Project  
 1010 Swan Valley Recreation and Wellness Centre  
 Phase One  
 Drawing  
 Roof Plan

Project  
 1010 Swan Valley Recreation and Wellness Centre  
 Phase One  
 Drawing  
 Section Details

1 Roof Plan  
 Scale: 1:100

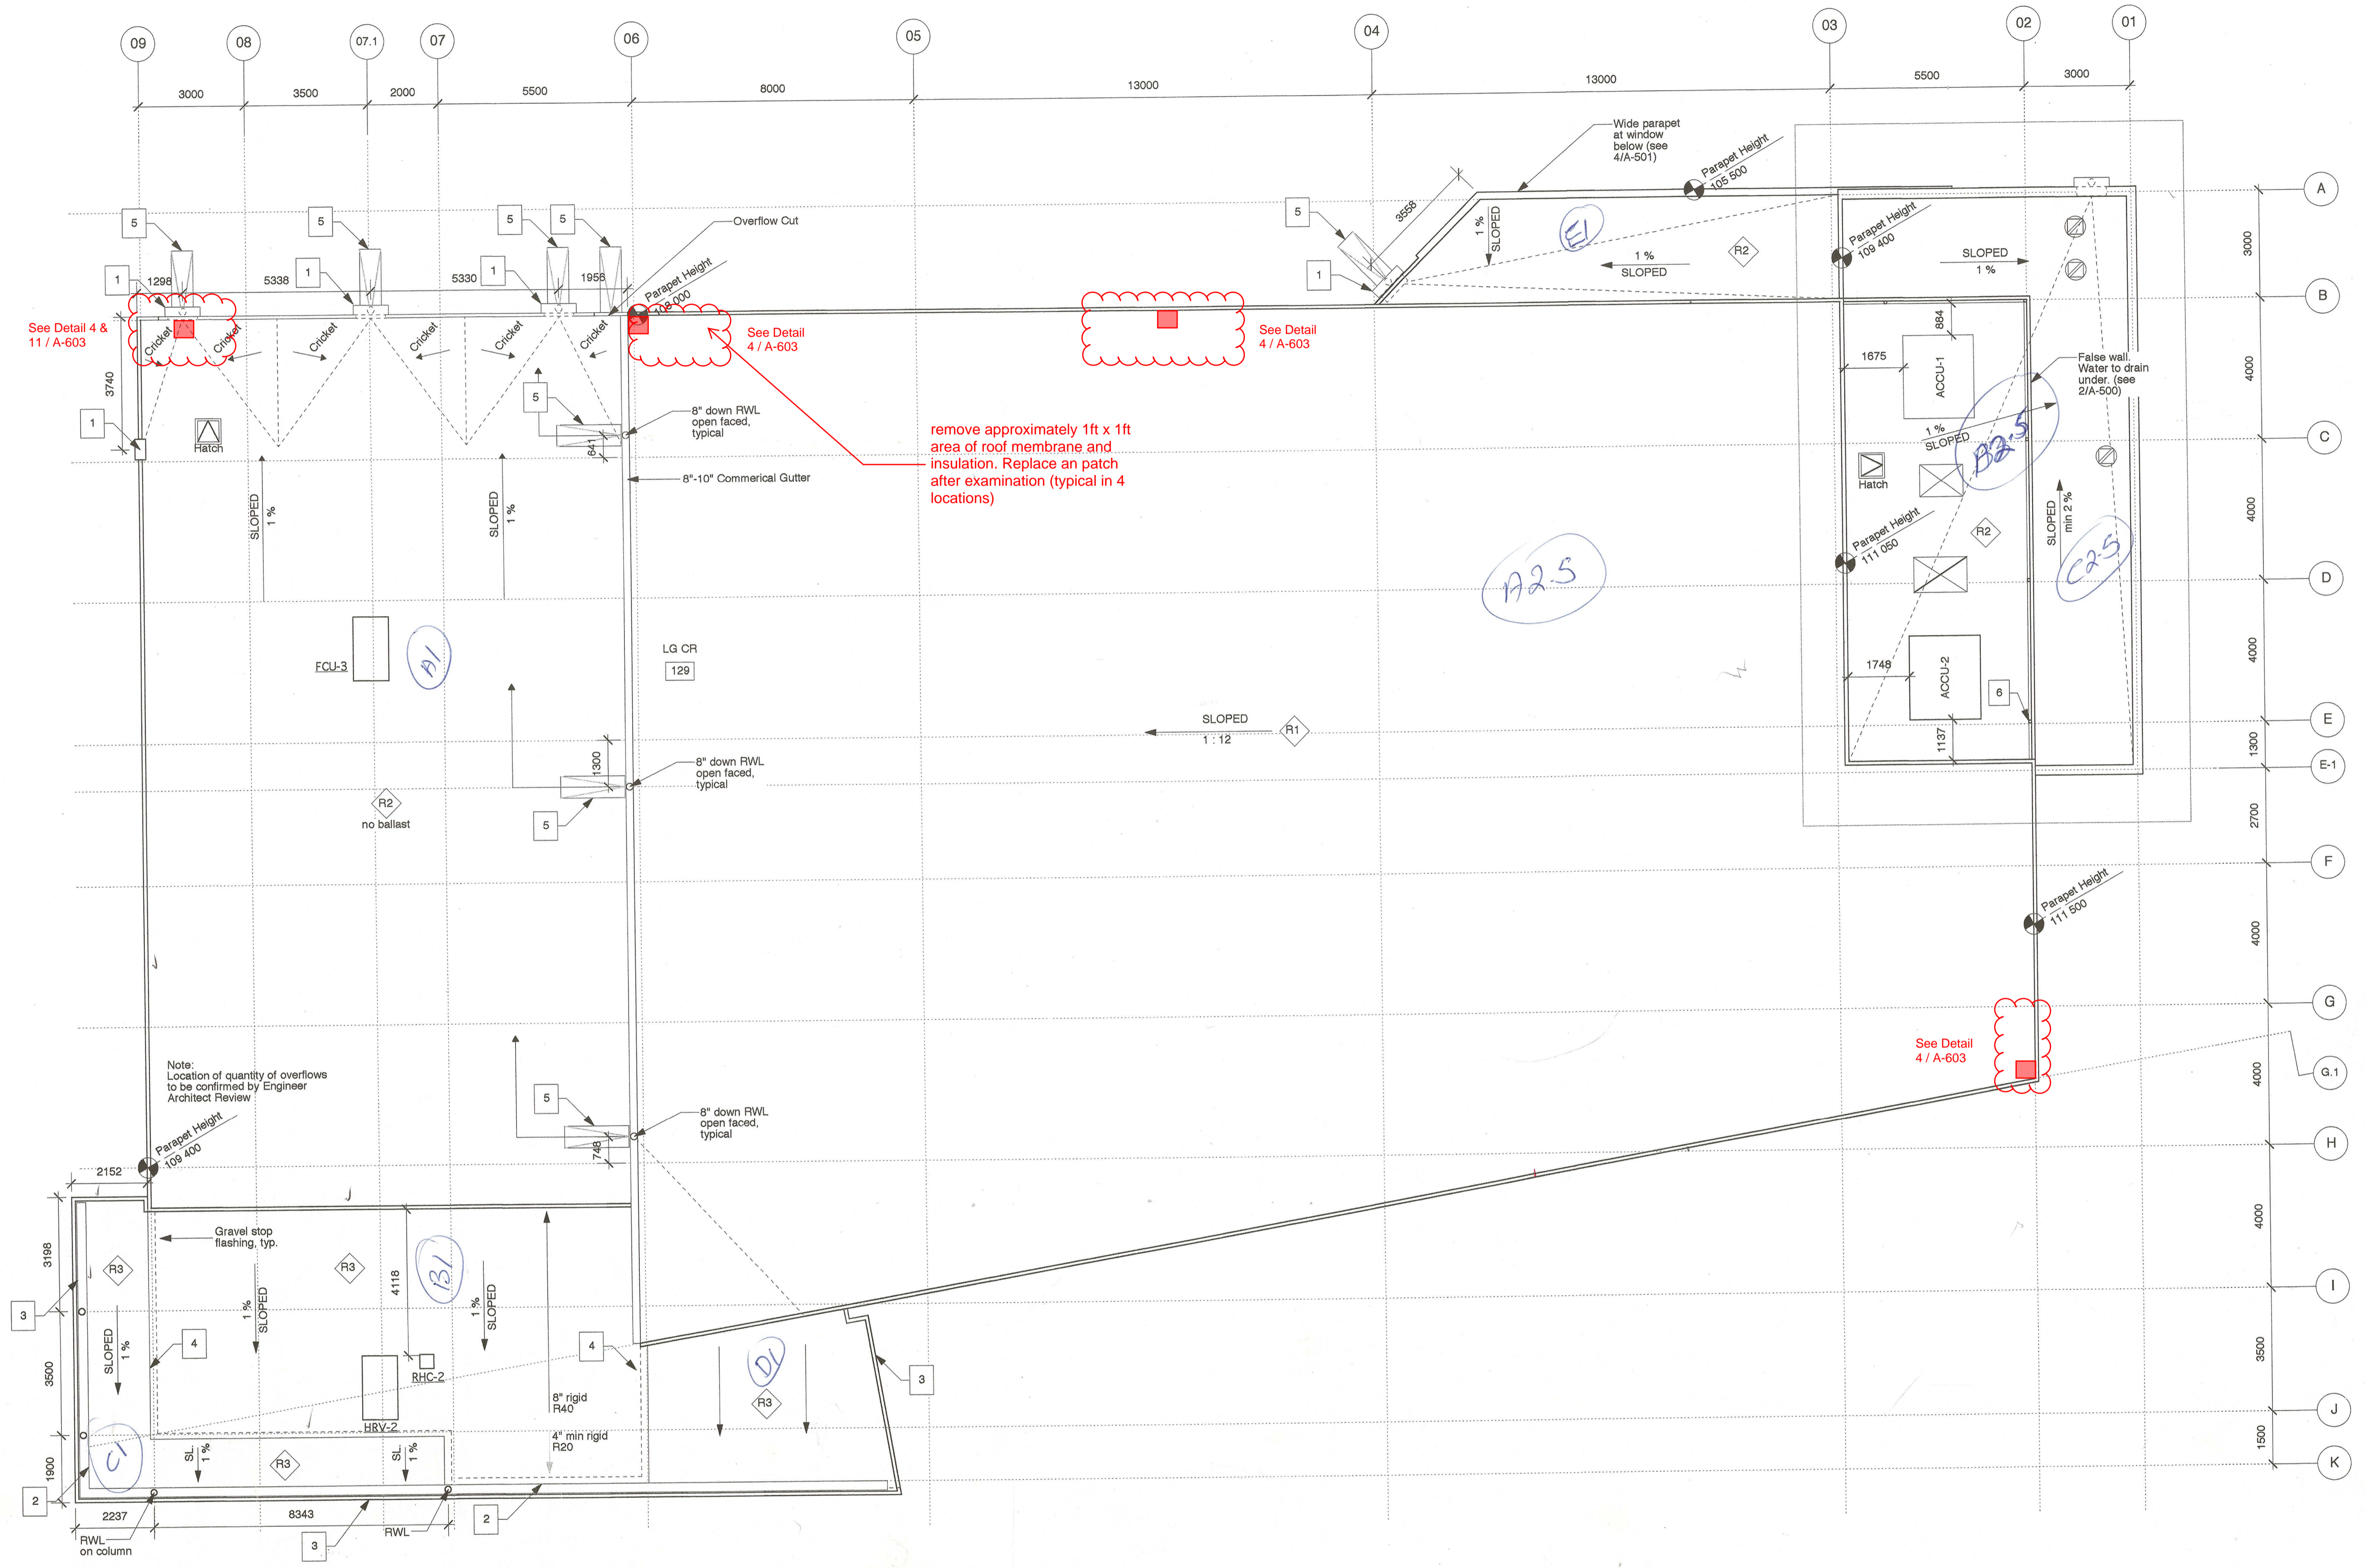
Note:  
 Location of quantity of overflows  
 to be confirmed by Engineer  
 Architect Review

remove approximately 1ft x 1ft  
 area of roof membrane and  
 insulation. Replace a patch  
 after examination (typical in 4  
 locations)

See Detail  
 4 / A-603

Reviewed By  
 PS  
 Drawing No.  
**A-603**

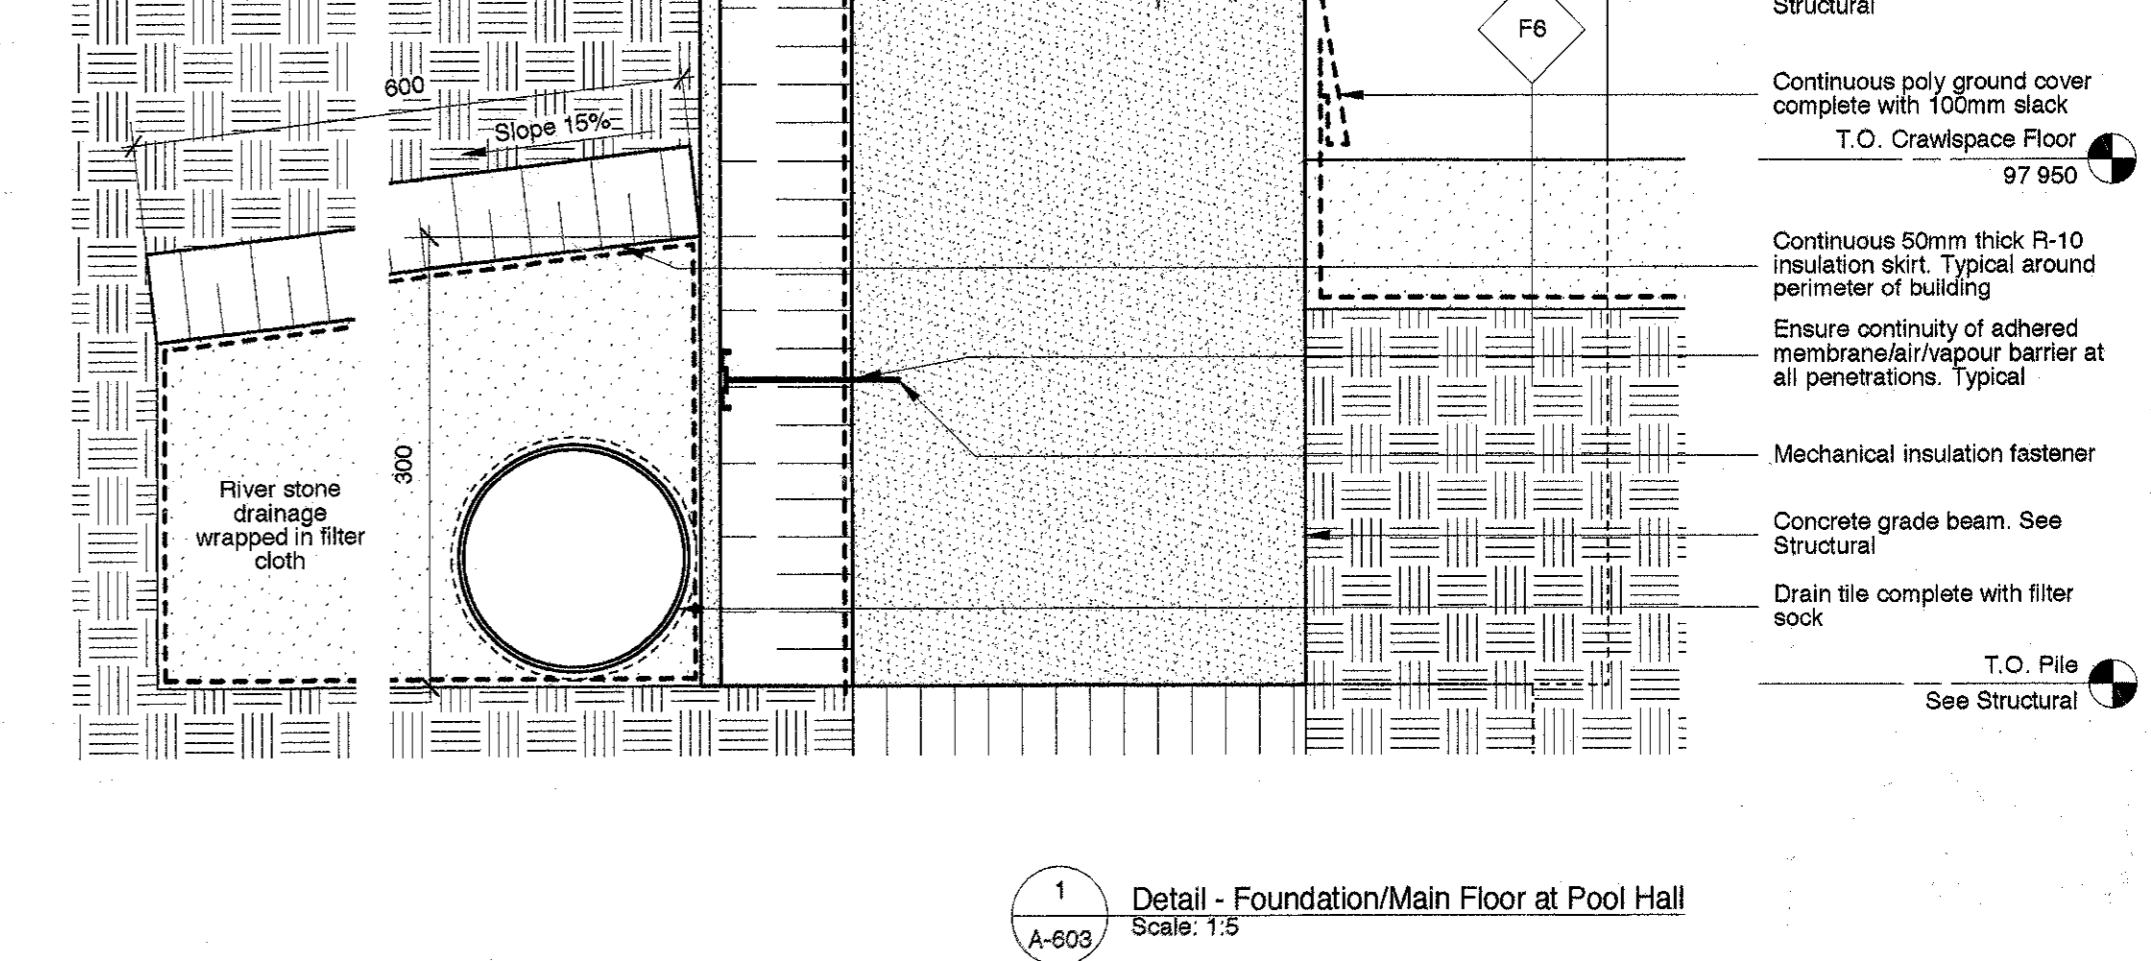
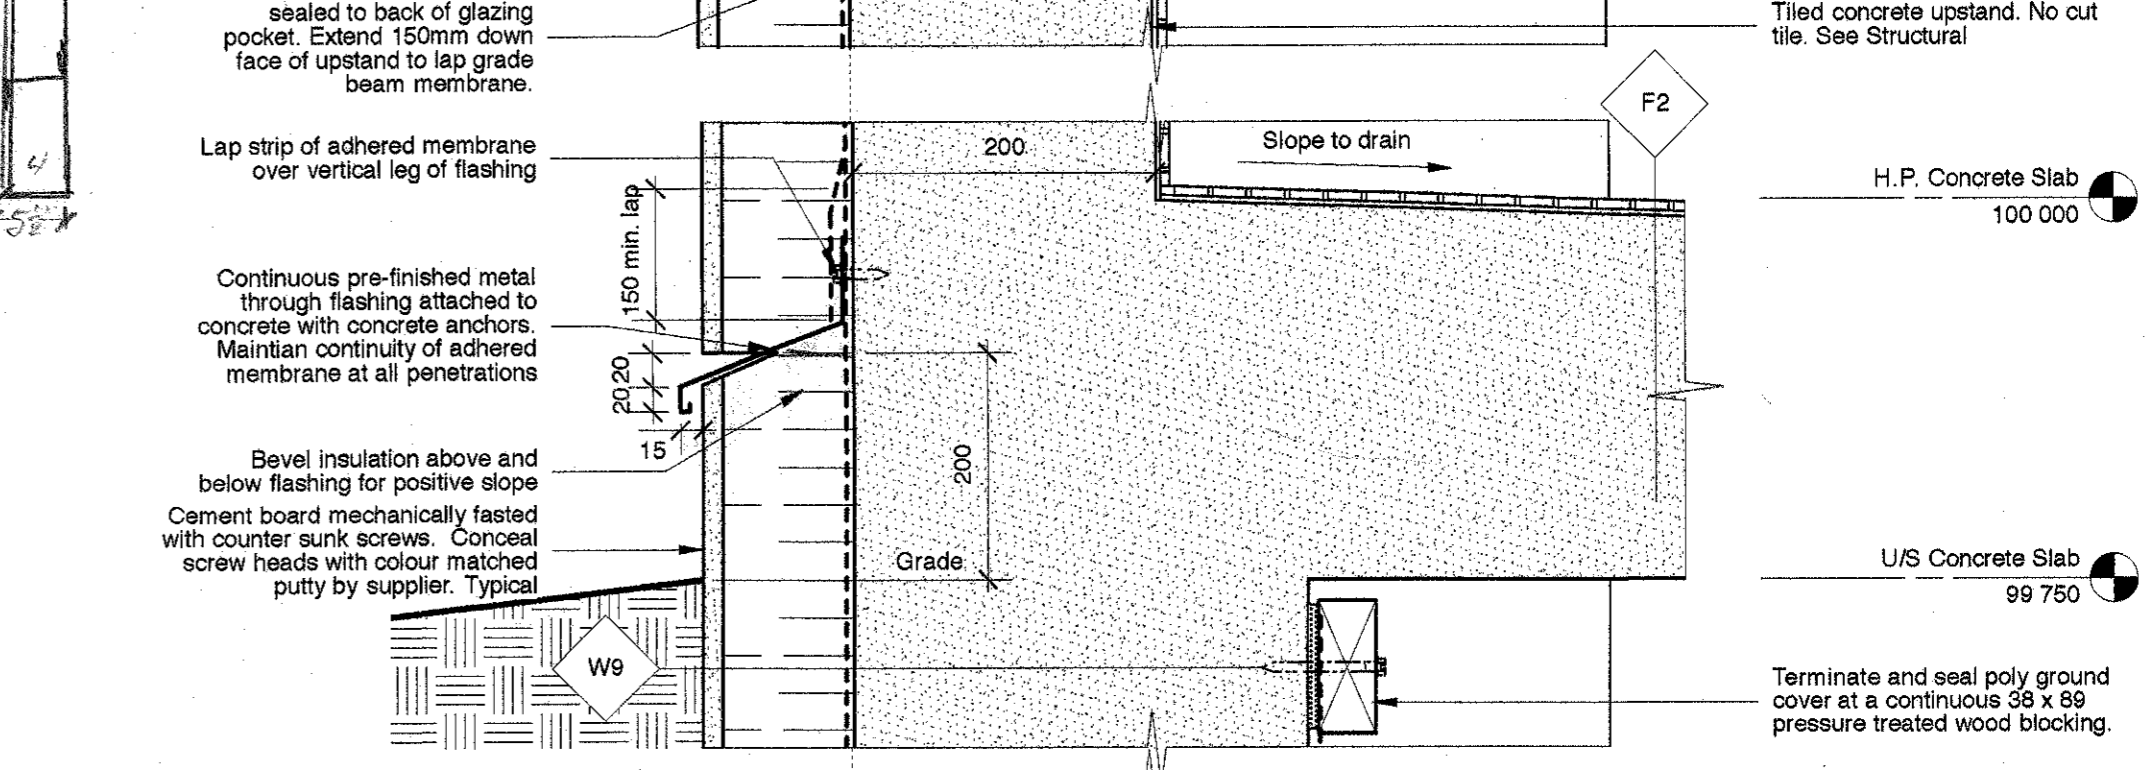
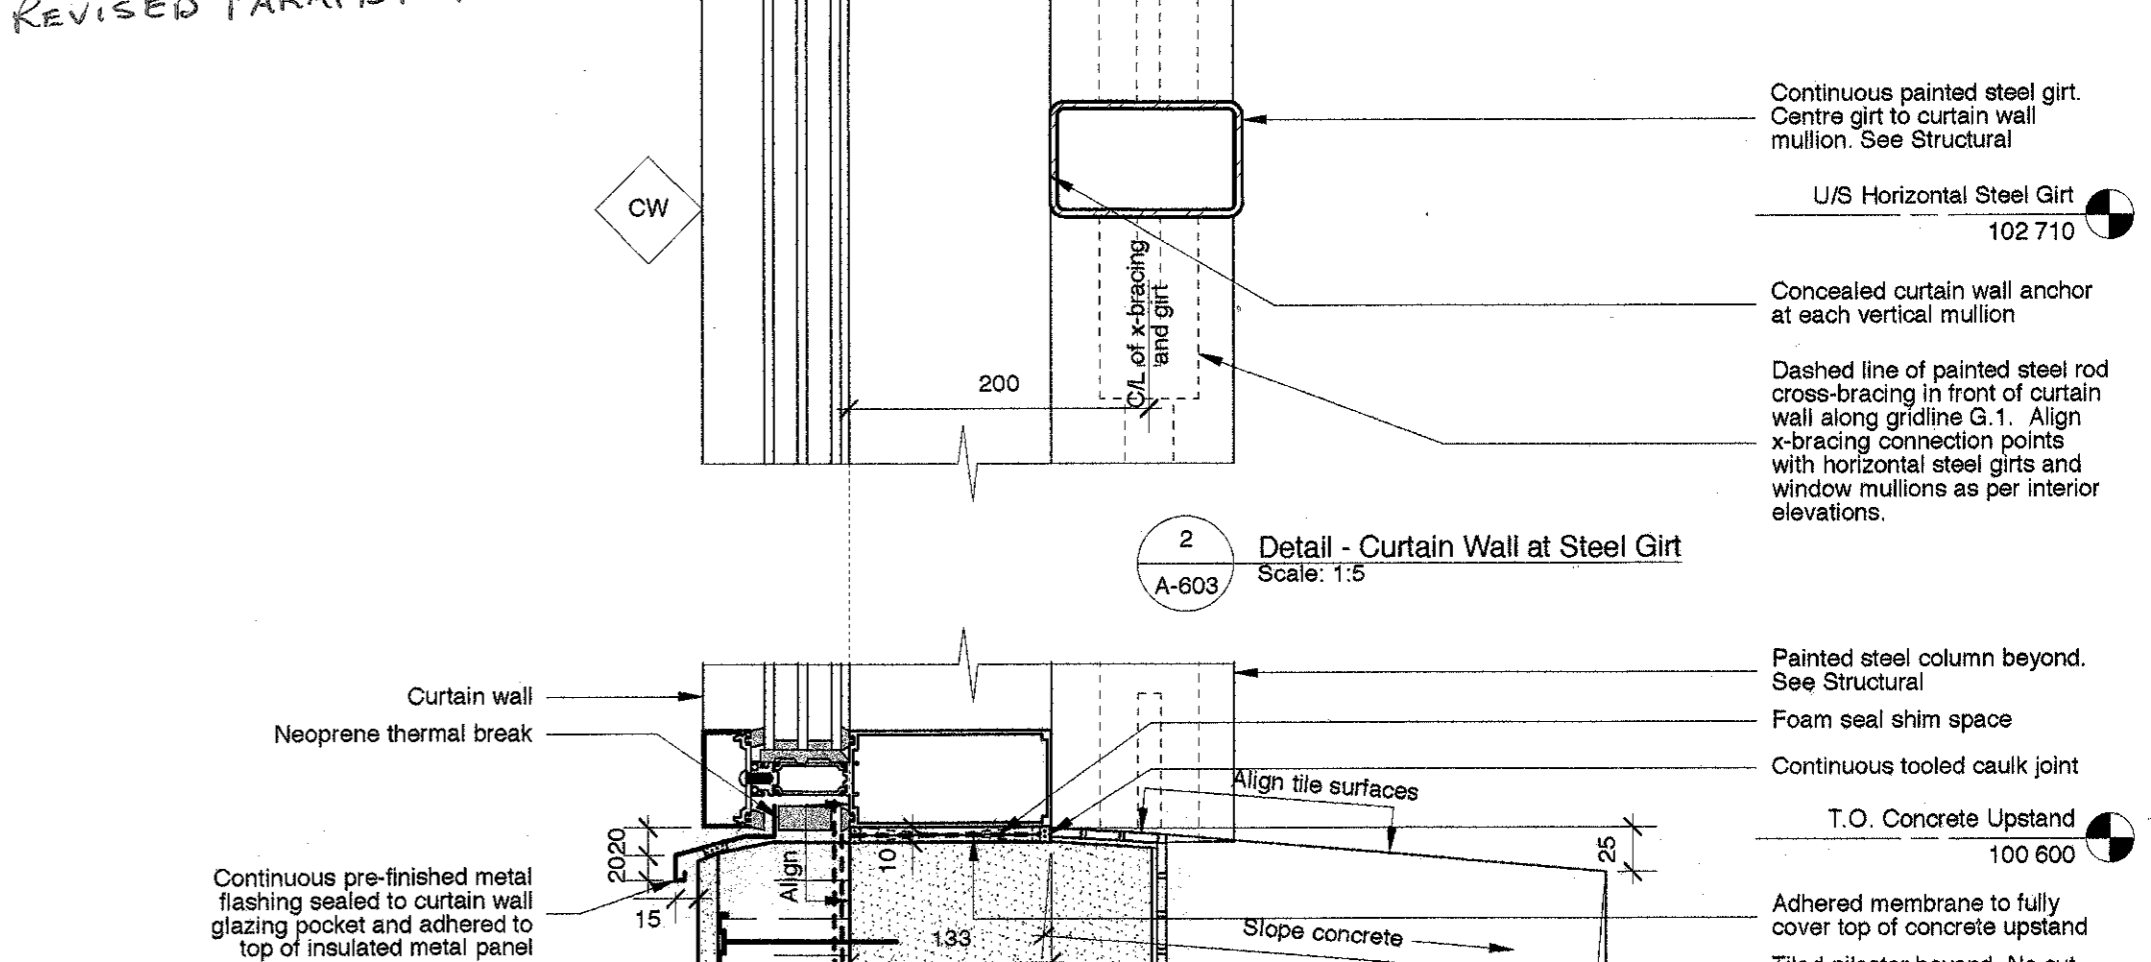
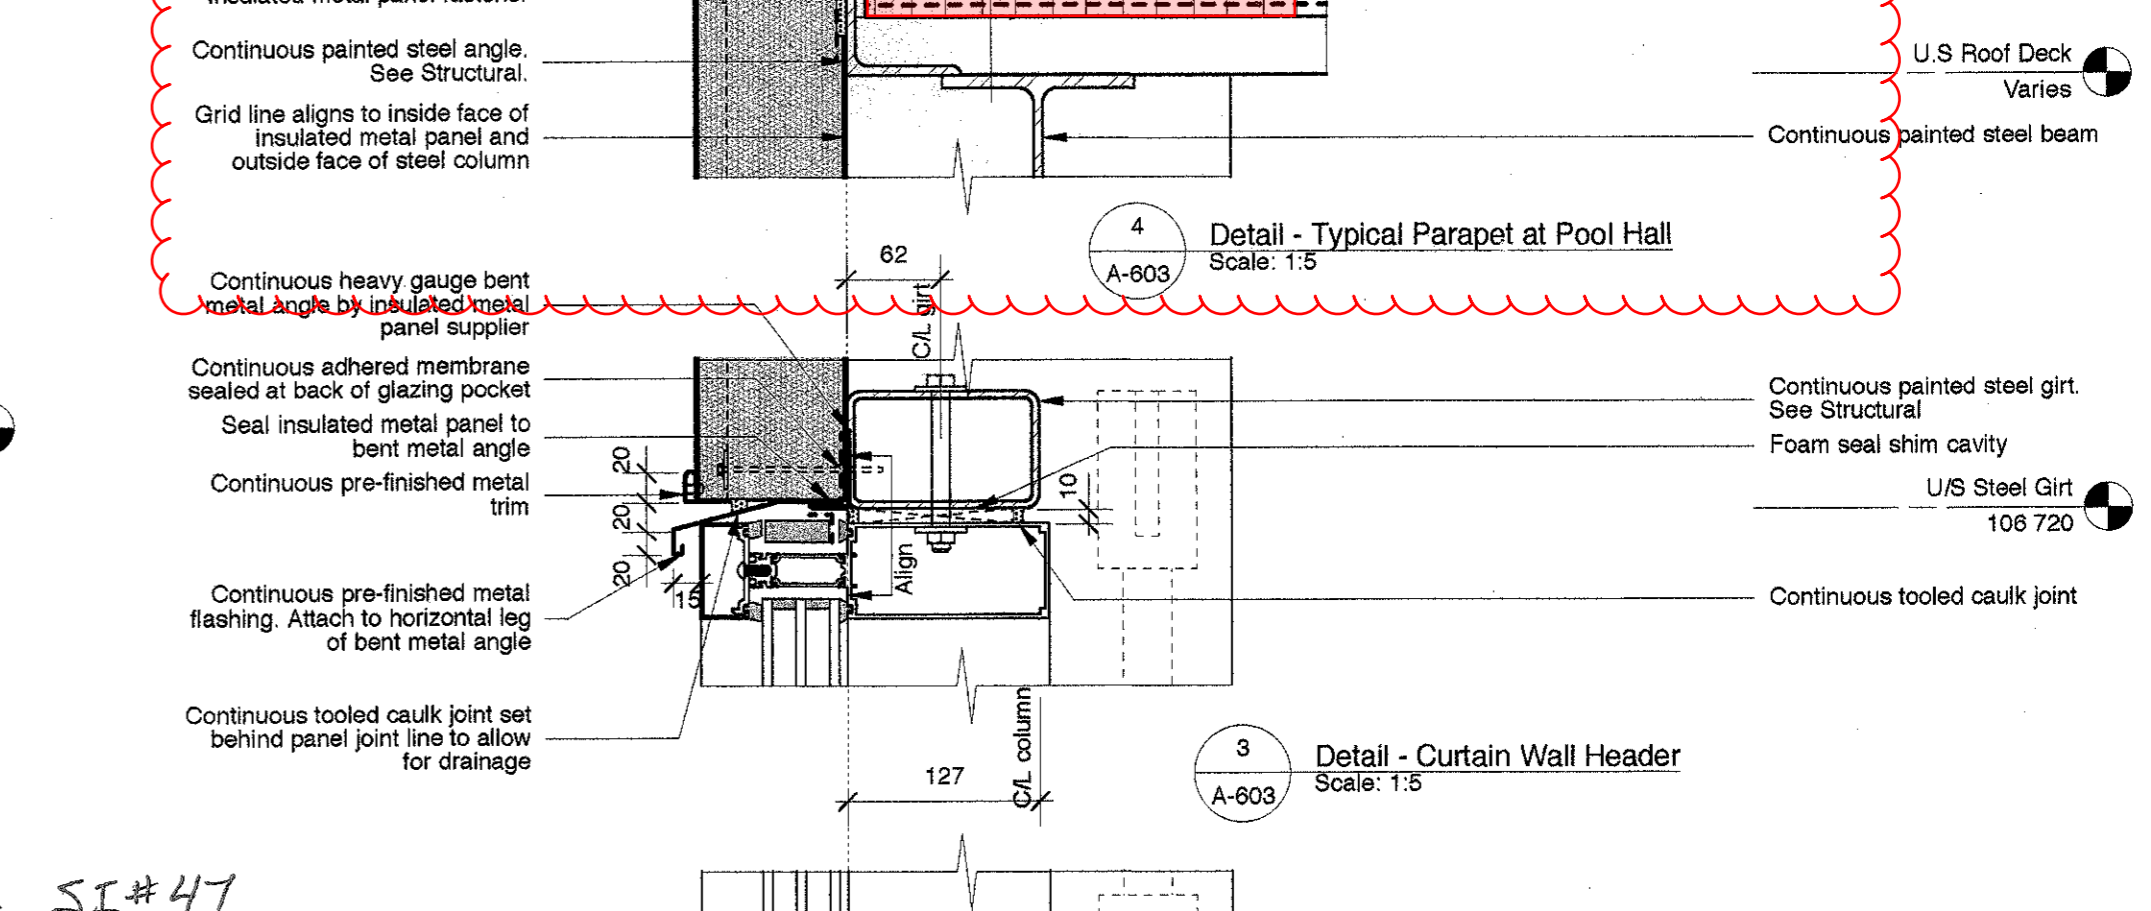
SEE SI#47  
 FOR REVISED PARAPET DETAILS

remove approximately 1ft x 1ft area of roof membrane and insulation, to expose roof deck and parapet plywood. Replace a patch after examination (typical in 4 locations) t
